Part 1: Foot of the Walk to Ocean Terminal walking and cycling route improvements

Spokes response to online survey 5.3.21

1. CONCEPT DESIGN - GREAT JUNCTION STREET

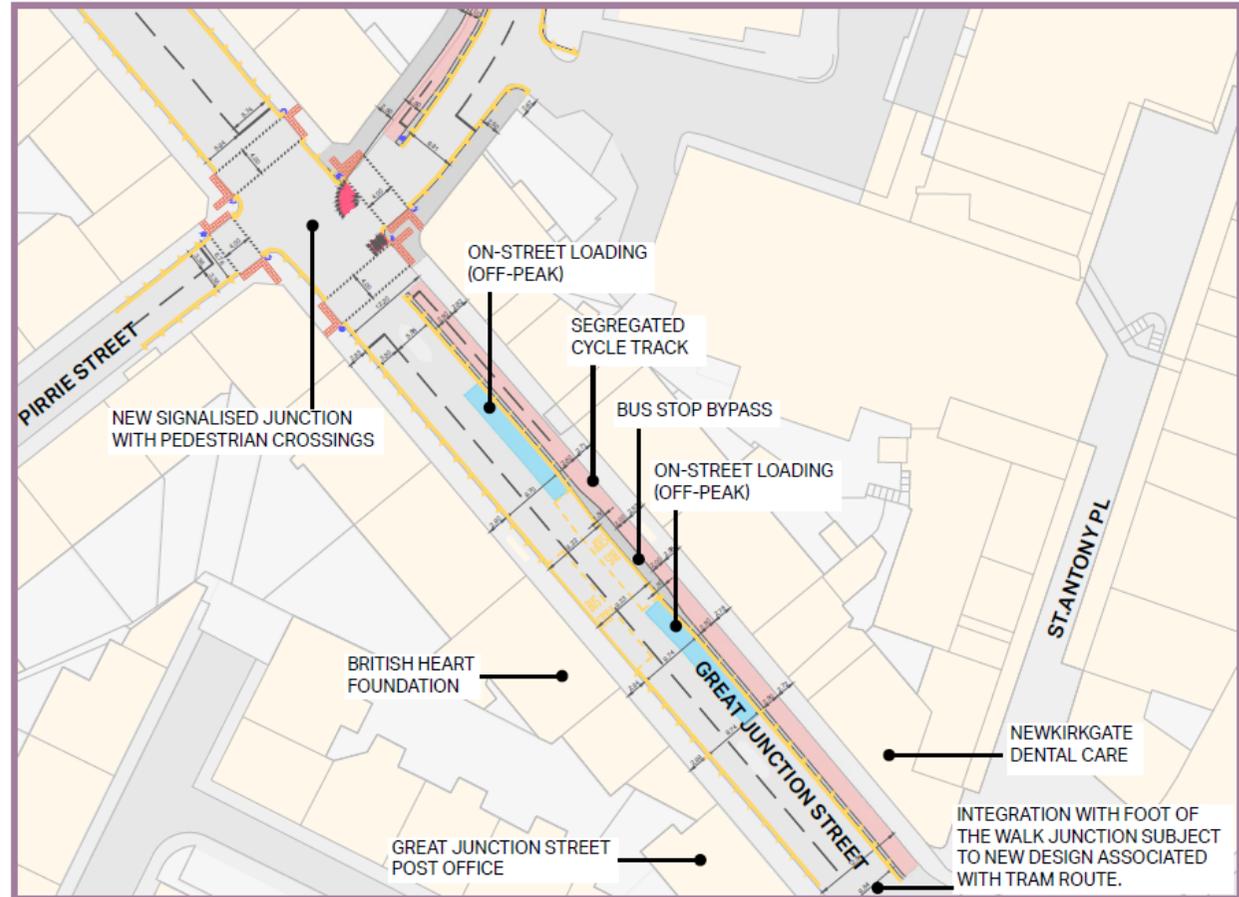
GQ1 The area is very busy with motor traffic and loading and unloading with no safe space for cycling and little room for pedestrians.

GQ2	GQ2: To what extent do you support the de-cluttering footways on Great Junction Street?
	Strongly support
	Could you briefly explain your view?
GQ3	GQ3: To what extent do you support the resurfacing of footways on Great Junction Street?
	Strongly support
	Could you briefly explain your view?
GQ4	GQ4: To what extent do you support/ oppose the proposal for a cycle track that is separated from pedestrian and motor traffic along Great Junction Street?
	Strongly support
	Could you briefly explain your view?
	GQ4 A safe connection is essential from the Foot of the Walk to Henderson Street. It is not clear from the proposal how cycle provision will continue across the junction to Henderson St nor how cyclists will be able to continue westwards along Gt Junction St or join the cycleway from the West. These manoeuvres need to be accommodated in a safe and intuitive manner. The cycleway needs to be of sufficient width to accommodate cargo and adapted bikes and to allow cyclists to pass one another.

2. CONCEPT DESIGN - HENDERSON STREET

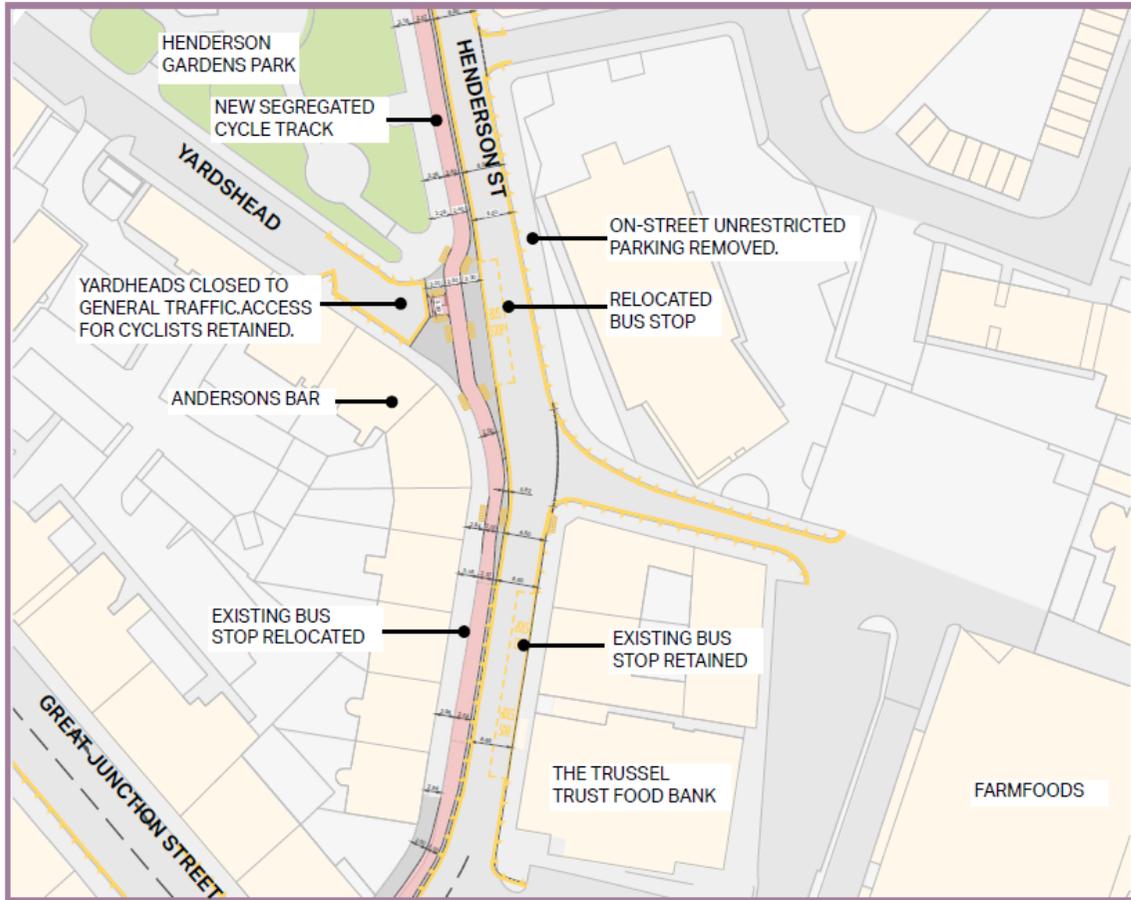
HQ1	To what extent do you support/ oppose the proposal for a cycle track that is separated from pedestrian and motor traffic along Henderson Street?
	Strongly support
	<p>Could you briefly explain your view?</p> <p>HQ1 Safe, consistent and intuitive cycle facilities are needed to accommodate all ages and abilities of cyclists and types of cycle/wheeling.</p>

<p>A suitable smooth surface needs to be provided without a steep camber rather than the existing cobbles. Safe access needs to be provided to and from the roads to the right of the cycleway, some of which will hopefully be improved as part of the LTN. Some concerns about the width restrictions. Would prefer unidirectional cycleways on each side of the road. Good to see priority over the roads to the left of the route, however the double yellow lines should continue across the junctions where the foot/cycleway is continuous to emphasise that the carriageway does not continue. Detailed design needs consideration.</p>
HQ2	<p>The proposals include new crossing improvements across Henderson Street. Do you have any preferred crossing locations or areas for improvement on the street?</p>
HQ3	<p>To what extent do you support/ oppose the removal of unrestricted parking on Henderson Street and Yardheads to provide more space for people walking, cycling and wheeling? Strongly support Could you briefly explain your view? HQ3 Car use needs to be discouraged as far as possible for unnecessary journeys and priority given to active travel in order to tackle health and climate problems.</p>

HQ4	<p>HQ4: To what extent do you support/ oppose restricting access by motor vehicle to Yardheads and Parliament Street via Henderson Street to provide more space and improve safety for people walking, cycling and wheeling? Strongly support Could you briefly explain your view? HQ4 These proposals are consistent with the proposal for a Low Traffic Neighbourhood and will make Henderson Street safer and more attractive for active travellers and people including tourists using the street to access local services. Yes - further secure parking should be provided towards the Shore.</p>
HQ5	<p>Secure bicycle parking is proposed on Henderson Gardens. Would you support further secure bicycle parking on Henderson Street? If so, what location? Strongly support</p>

6. CONCEPT DESIGN - SANDPORT PLACE

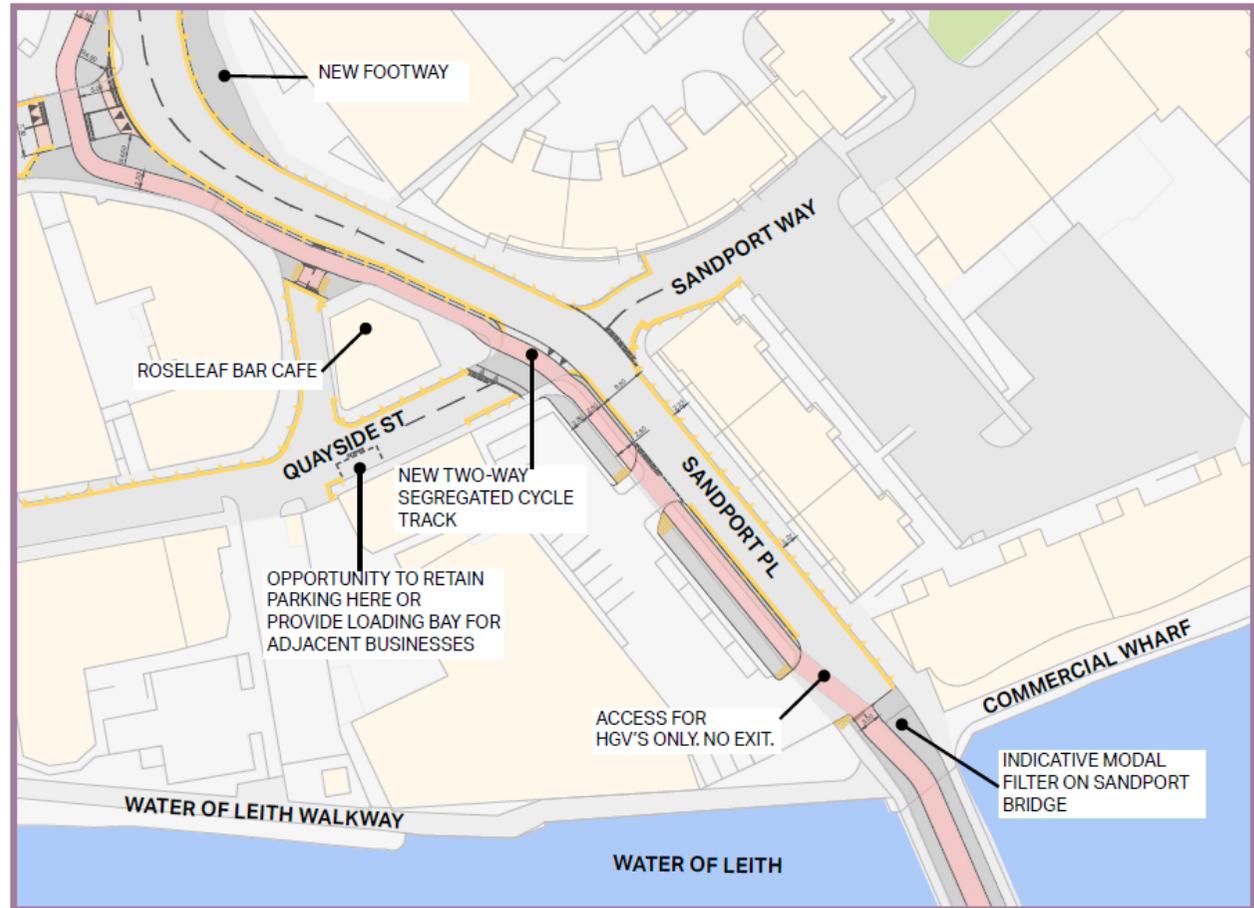
SQ1	<p>To what extent do you support/ oppose the proposal for a cycle track that is separated from pedestrian and motor traffic along Sandport Place?</p> <p>Strongly support</p>
	<p>Could you briefly explain your view?</p> <p>SQ1 This is a key link in the cycleway. It is important to provide consistent cycling facilities along the whole of the route. Continuous</p>

<p>double yellow lines required across cycling-priority junctions. Safe cycling access is required to/from roads to the right of the cycleway.</p> <p>We support the closing of Parliament St to general traffic - this makes the crossing safer and allows an alternative access to the Water of Leith for cyclists.</p>
SQ2	<p>To what extent do you support/ oppose the proposed closure of Sandport Place Bridge to through motor vehicle traffic to provide more space for people walking, cycling and wheeling?</p> <p>Strongly support</p>
	<p>Could you briefly explain your view?</p> <p>SQ2 It is vital to close the bridge to through traffic in order to make this a safe and attractive area for walking and cycling. Also, improved access to the Water of Leith path and an alternative cycling route along Coburg Street.</p>
SQ3	<p>With Sandport Place Bridge closed to through traffic, Sandport Place will have low volumes of vehicle traffic. There could be an opportunity to keep cyclists on road on a relatively quiet street. However, there are issues with existing cobbled road surface and a number of business accesses on this stretch. Would you have a preference of the following provision for cyclists on Sandport Place?</p> <p>Segregated cycle track, as proposed in design (separated from road and pavement)</p>

<p>Other ([please specify)</p> <p>SQ3 A segregated route is needed due to the cobbles and the vehicular access to businesses. Cyclists need to be given clear priority over motor traffic so that children and leisure cyclists can travel safely through this popular area.</p>
SQ4	<p>To what extent do you support/ oppose the proposed two way bus gate (and removal of general traffic) on the Shore to improve conditions for people walking and cycling and enjoying the area?</p> <p>Strongly support</p>
	<p>Could you briefly explain your view?</p> <p>SQ4 The Shore is a very popular leisure area and should be safe for people to wander and for leisure. Steps should be taken to improve the surface for cycling. This should include closing access to/from Burgess St, which appears to be the case in the diagram. If there are issues with the proposals for The Shore, these should not be allowed to delay implementation of the remaining measures.</p>

7. CONCEPT DESIGN - DOCK STREET

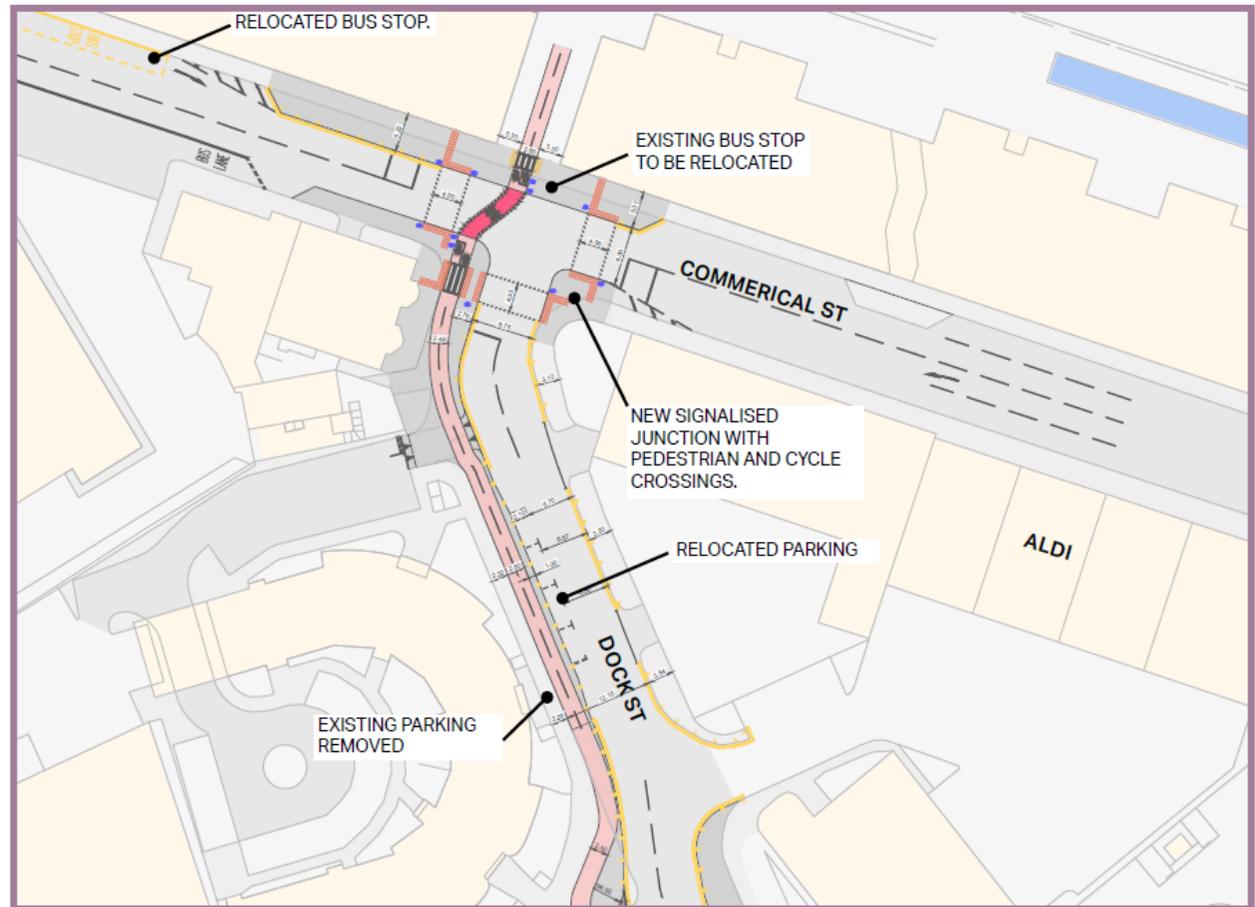
DQ1	To what extent do you support/ oppose the proposal for a cycle track that is separated from pedestrian and motor traffic along Dock Street?
	Strongly support

<p>Could you briefly explain your view?</p> <p>DQ1 As previously, part of a route consistently offering safe and intuitive cycling facility.</p>
DQ2	<p>To what extent do you support the removal of unrestricted parking on Dock Street to provide more space for people walking, cycling and wheeling?</p> <p>Strongly support</p>
	<p>Could you briefly explain your view?</p> <p>DQ2 As previously, road space should give priority for active travel and support reduced vehicle usage.</p>
DQ3	<p>To what extent do you support the proposed junction and pedestrian crossing improvements at Commercial Street?</p> <p>Strongly support</p>
	<p>Could you briefly explain your view?</p> <p>DQ3 We support the general proposal and is the best of the 3 options that were under consideration. By having a continuous island to the right of the cycleway it would seem that separate pedestrian and cycle crossing phases may not be required. Spokes thinks that it could be further improved by: reducing the width of the carriageway, potentially to a single lane and straightening the cycle crossing.</p>

DQ4	<p>To what extent do you support/ oppose restricting motor vehicle access from the western end of Coburg Street to provide more space and safer conditions for people walking, cycling and wheeling and improving access to the Water of Leith Walkway?</p> <p>Strongly support</p>
	<p>Could you briefly explain your view?</p> <p>DQ4 Coburg Street should become a formalised cycle route in order to reduce cycle traffic on the very narrow section of the Water of Leith path. Restricting vehicular access from the West would help to make this a more suitable route for cycling, hopefully with further measures to come as part of the Low Traffic Neighbourhood. Ideally Coburg Street should be closed to through traffic.</p>
